Service Bulletin

SB07-80-01

SKY-TEC STARTER INSTALLATION

To announce that modification kits are available to provide customers the option of installing a Sky-Tec manufactured starter in place of a Lamar manufactured starter.

Figure 1. 172 Sky-Tec Starter Installation (Sheet 1)

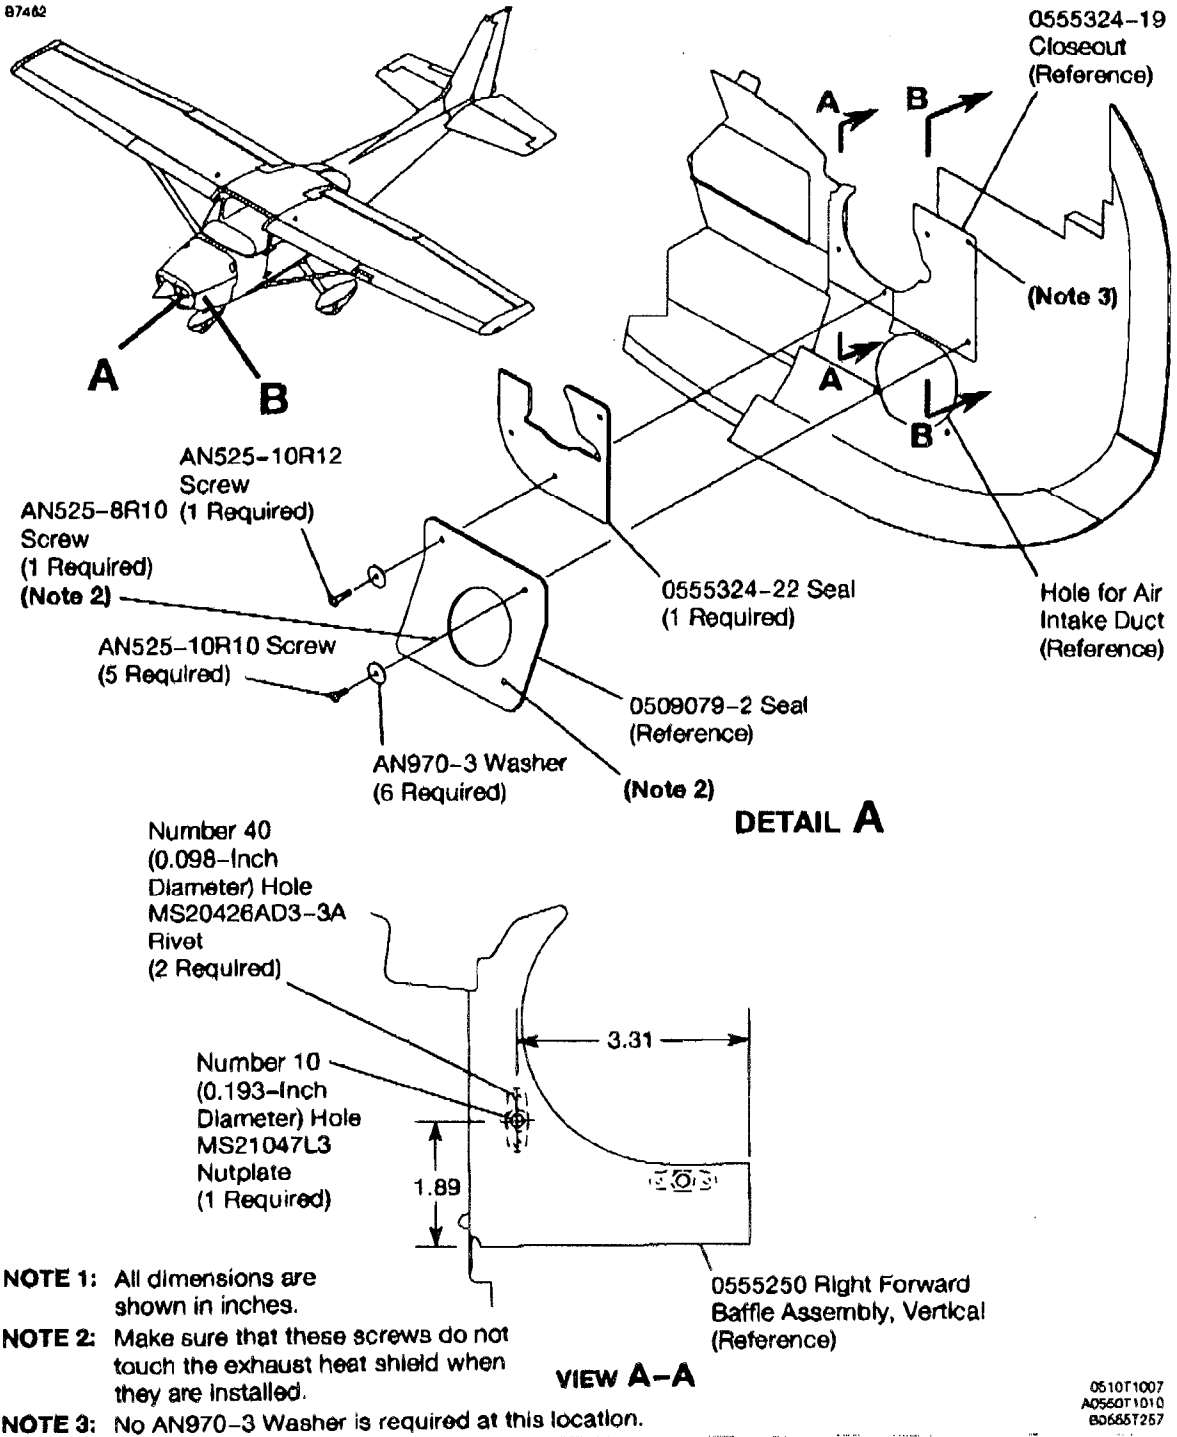
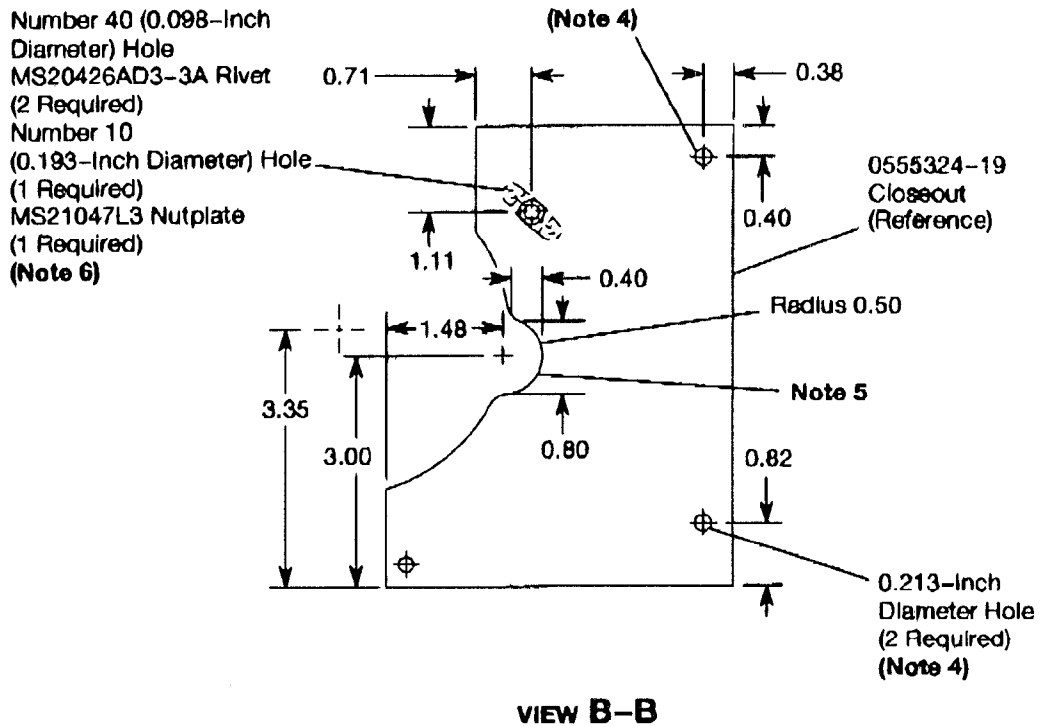
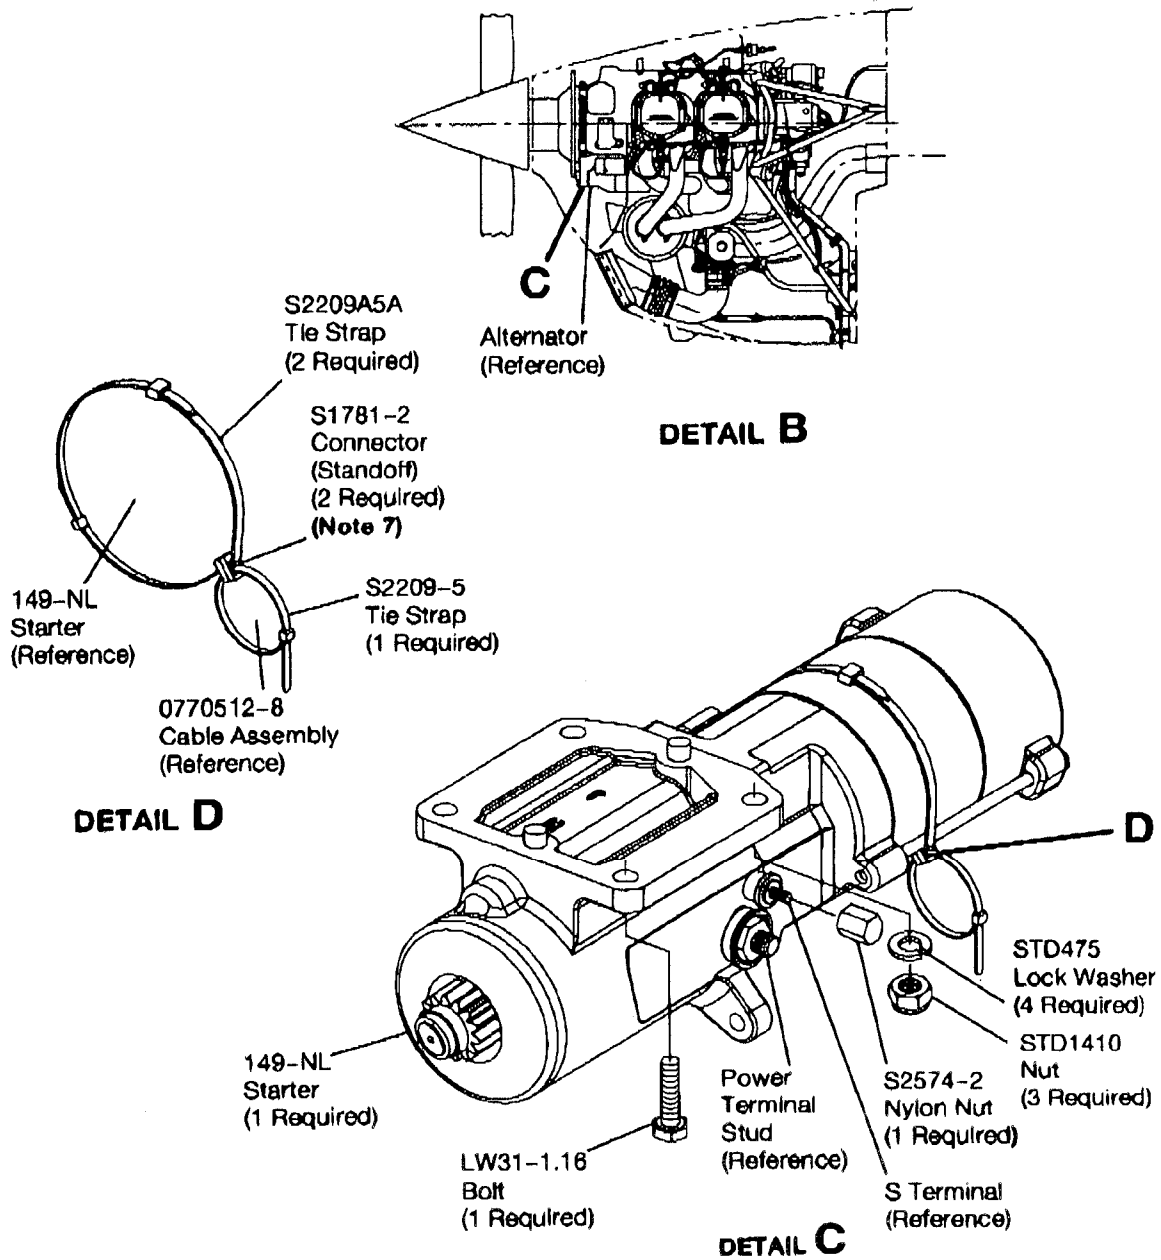
- 3. Begin the modification to the engine baffle installation as follows:
 - A. (Refer to Figure 1, Detail A.) Remove the four screws from the air intake duct that goes through the hole in the 0509079-2 Seal. Keep the screws.

- 6. Continue the modification to the engine baffle installation as follows:
 - A. (Refer to Figure 1, View B-B.) Do a modification to the 0555324-19 Closeout as follows:

- (1) Trim the 0555324-19 Closeout to make a space for the 149-NL Starter start cable to go through the engine baffle.
 - (2) With a Number 3 drill, change the dimension of each of the two outboard holes from 0.194 inch in diameter to 0.213 inch in diameter as shown.

- (3) Drill a new Number 10 (0.193-inch diameter) hole in the 0555324-19 Closeout.
 - (4) Drill two Number 40 (0.098 inch-diameter) holes with a countersink in the 0555324-19 Closeout for the MS20426AD3-3A Rivets that attach the MS21047L3 Nutplate.

- B. (Refer to Figure 1, View A-A.) Do a modification to the 0555250 Right Forward Baffle Assembly as follows:
 - (1) Drill a new Number 10 (0.193-inch diameter) hole in the 0555250 Right Forward Baffle Assembly.

- (2) Drill two Number 40 (0.098 inch-diameter) holes with a countersink on the forward side in the 0555250 Right Forward Baffle Assembly for the MS20426AD3-3A Rivets that attach the MS21047L3 Nutplate.

C. (Refer to Figure 1, Detail C.) With the three STD1410 Nuts, one LW31-1.16 Bolt, and four STD475 Lock Washers, install the 149-NL Starter. (Refer to the Model 172 Series 1996 and On Maintenance Manual, Chapter 80, Starter - Maintenance Practices.)

A. (Refer to Figure 1, Detail C.) Connect the ring terminal to the power terminal stud on the 149-NL Starter.

C. (Refer to Figure 1, Detail C and Detail D.) Attach the 0570512-8 Start Cable Assembly to the 149-NL Starter with the two S2209A5A Tie Straps, one S2209-5 Tie Strap, and two S1781-2 Connectors (Standoffs).

NOTE 4: Change the dimension of each of the two holes from 0.194 inch in diameter to 0.213 inch in diameter.

NOTE 5: Trim here to make a space for the 149-NL Starter start cable to go through the engine baffle.

NOTE 6: Install the MS21047L3 Nutplate on the aft side of the 0555324-19 Closeout.

NOTE 7: Install the S1781-2 Connectors (Standoffs) in a position that does not let the 0770512-8 Start Cable Assembly move and that gives the maximum distance possible between the 149-NL Starter and the 0770512-8 Start Cable Assembly.

Figure 2. 0570512-8 Start Cable Assembly Installation (Sheet 1)

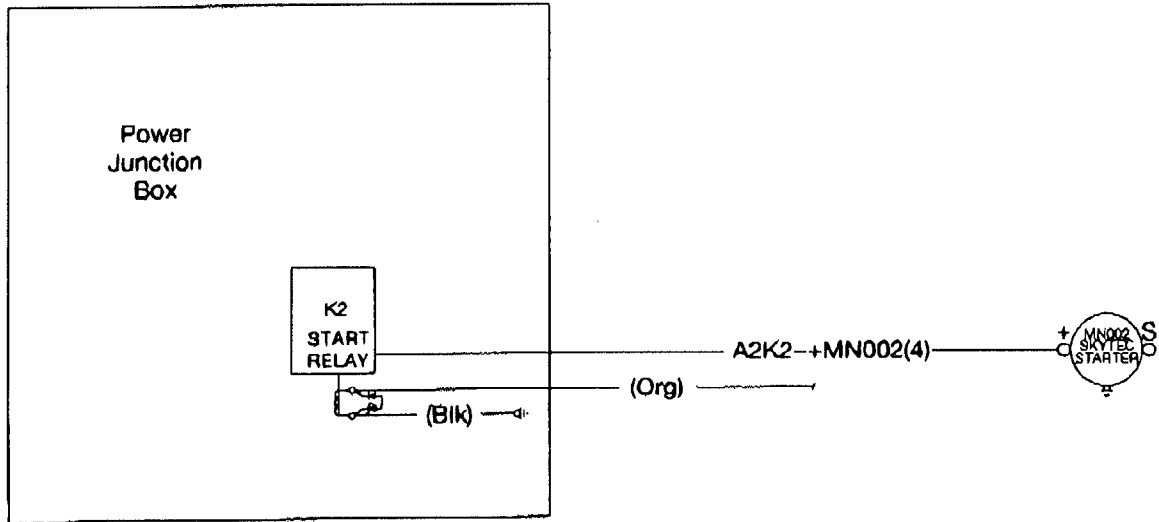
8. (Refer to Figure 1, Detail B and Figure 2.) Replace the start cable assembly that goes from the starter relay to the starter as follows:

NOTE: The 0570512-3 Start Cable Assembly is too short to be used for the installation of the 149-NL Starter.

A. Remove and discard the 0570512-3 Start Cable Assembly.

(1) Do the routing of the 0570512-8 Start Cable Assembly along the existing wire bundle and inside the black conduit to the 149-NL Starter. Attach the 0570512-8 Start Cable Assembly to the existing wire bundle as necessary with S2209-5 Tie Straps to the wire bundle.

(2) Connect the ring terminal on the end of the 0570512-8 Start Cable Assembly to the stud on the X61-0027 Starter Relay.

(3) Torque the stud nut on the X61-0027 Starter Relay to 40 inch-pounds, +5 or -5 inch-pounds.

Figure 1. 182 Sky-Tec Starter Installation (Sheet 1)

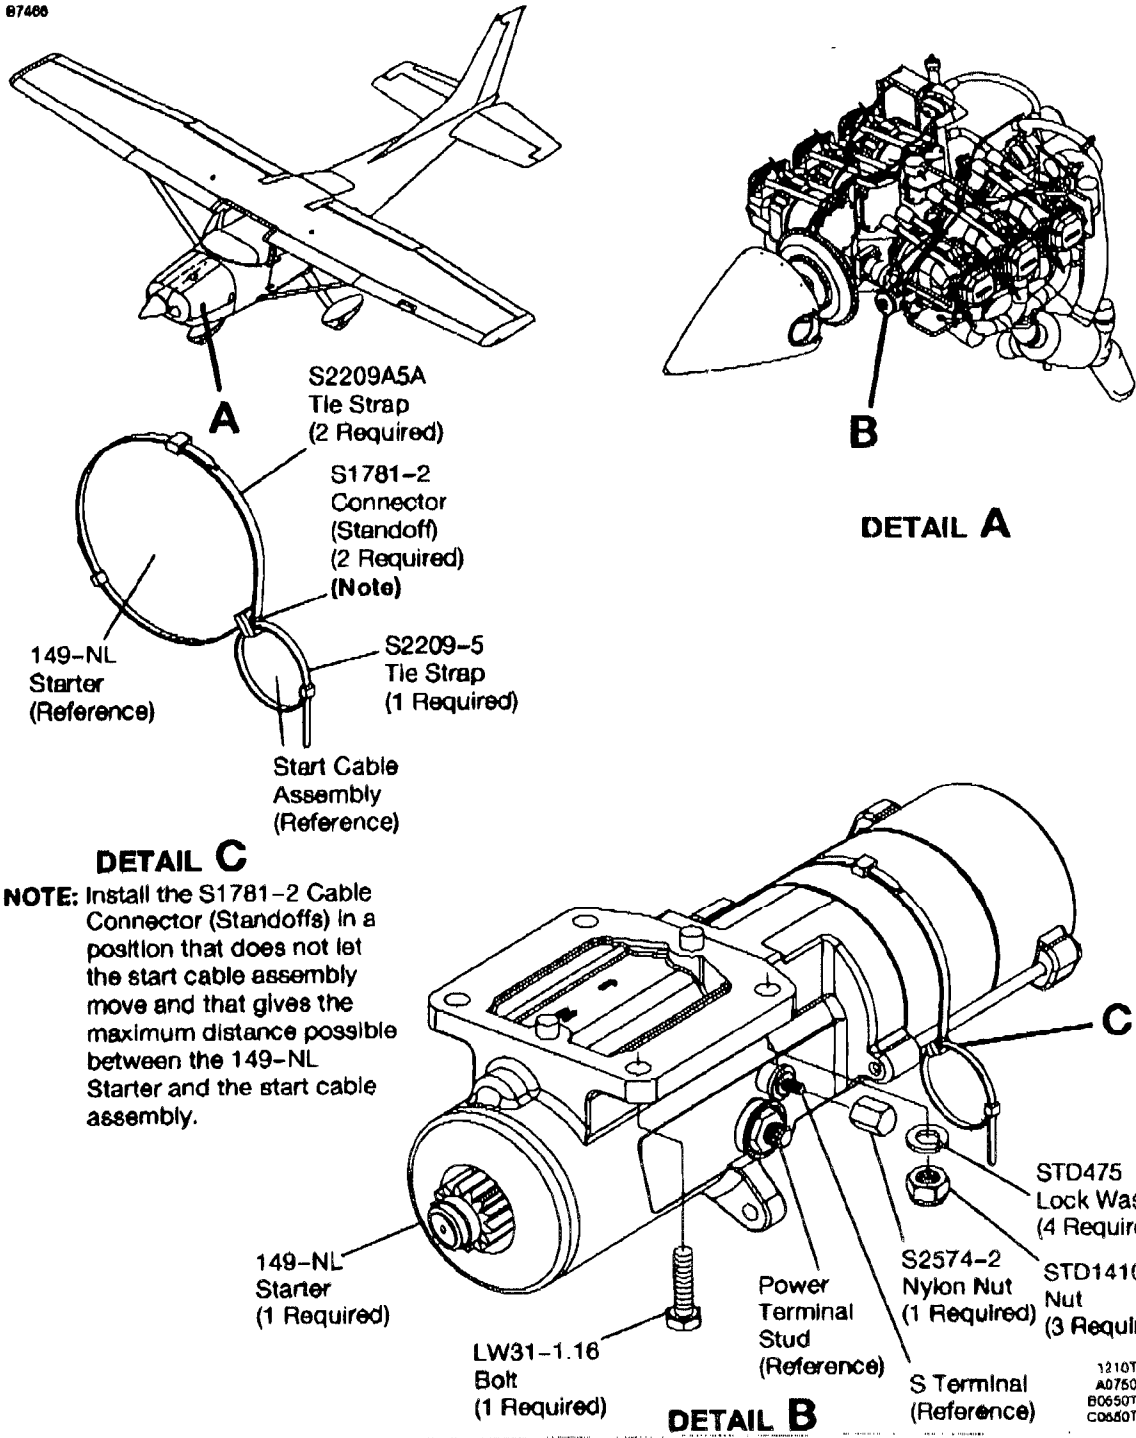
- C. Remove and discard the PM2401 Starter and attaching hardware. (Refer to the Model 182/T182 Series 1997 and On Maintenance Manual, Chapter 80, Starter - Maintenance Practices.)
- D. Install the 149-NL Starter as follows:
 - (1) Discard the jumper wire that comes with the starter. You will not need it.
 - (2) Remove and discard the S Terminal nut that comes with the starter and install the S2574-2 Nylon Nut on the S Terminal.
 - (3) With the three STD1410 Nuts, one LW31-1.16 Bolt, and four STD475 Lock Washers, install the 149-NL Starter. (Refer to the Model 182/T182 Series 1997 and On Maintenance Manual, Chapter 80, Starter - Maintenance Practices.)

- (4) Torque the LW31-1.16 Bolt and the three STD1410 Nuts to 204 inch-pounds. (Refer to the Model 182/T182 Series 1997 and On Maintenance Manual, Chapter 20, Torque Data - Maintenance Practices.)

4. (Refer to Figure 1, Detail B and Figure 2.) Attach the existing 0770512-3 (or 0770512-5) Start Cable Assembly to the starter relay and to the starter as follows:

- C. On some airplanes, you may have to make small adjustments to the routing of the 0770512-3 (or 0770512-5) Start Cable Assembly to make sure that there is sufficient length to attach the cable ring terminal on the power terminal stud on the starter.

Figure 2. 0770512-3 (or 0770512-5 or 0770512-7) Start Cable Assembly Installation (Sheet 1)

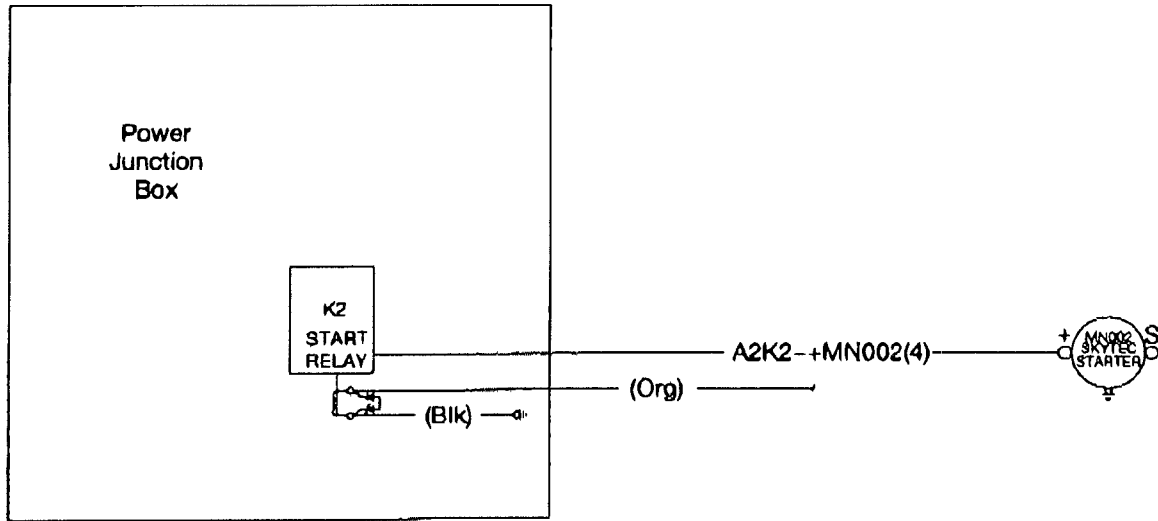
- A. Connect the ring terminal on the end of the 0770512-3 (or 0770512-5) Start Cable Assembly to the stud on the X61-0027 Starter Relay.
 - B. Torque the stud nut to 40 inch-pounds, +5 or -5 inch-pounds.

- (1) If the 0770512-3 (or 0770512-5) Start Cable Assembly has the necessary length to connect to the new 149-NL Starter, attach the 0770512-3 (or 0770512-5) Start Cable Assembly as necessary with S2209-5 Tie Straps to the wire bundle and go to Step 4D.

- (2) (For some T182T model airplanes) If the 0770512-5 Start Cable Assembly does not have the necessary length to connect to the new 149-NL Starter, you must do as follows:

- (a) Remove the 0770512-5 Start Cable Assembly from the airplane.
 - (b) Install and do the routing of the new 0770512-7 Start Cable Assembly along the existing wire bundle.

- (c) Attach the 0770512-7 Start Cable Assembly as necessary with S2209-5 Tie Straps to the wire bundle and go to Step 4D.
- D. Do the routing of the 0770512-3 (or 0770512-5 or 0770512-7) Start Cable Assembly to the 149-NL Starter with the two blue S2209A5A Tie Straps, one S2209-5 Tie Strap, and two S1781-2 Connectors (Standoffs). Install the S1781-2 Connectors (Standoffs) in a position that does not let the 0770512-3 (or 0770512-5 or 0770512-7) Start Cable Assembly move and that gives the maximum distance possible between the starter and the 0770512-3 (or 0770512-5 or 0770512-7) Start Cable Assembly.

- E. Connect the ring terminal on the end of the 0770512-3 (or 0770512-5 or 0770512-7) Start Cable Assembly to the power terminal stud on the 149-NL Starter.

- F. Torque the power terminal stud nut to 50 inch-pounds +5 or -6 inch-pounds, and install the protective boot that is on the 0770512-3 (or 0770512-5 or 0770512-7) Start Cable Assembly over the terminal.
